DEVELOPMENT HEARING OFFICER

PR-2024-010464

VA-2024-00165 – SIDEWALK WAIVER
IDO -2022

ON THE LEVEL BUILDERS | DAVID CAMPBELL agent for KATE NOVINC requests the aforementioned action(s) for all or a portion of: LOT 9, BLOCK 10, GLENWOOD HILLS NORTH UNIT 1 zoned R-A, located 4901 Glenwood Hills Dr NE between NUBE BLANCA and MANITOBA DR NE containing approximately 0.278 acre(s). (F-23)

FIGURE 7.2.41 Street Element Dimensions Along Major Roads

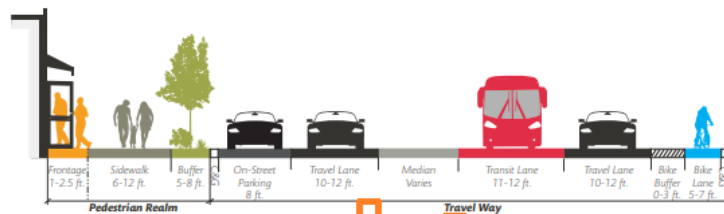
- 5-3(D)(1)(a) Perimeter sidewalks shall be provided in accordance with the DPM.
- Be in compliance with Table 7.2.29 of the DPM; see exhibit below.
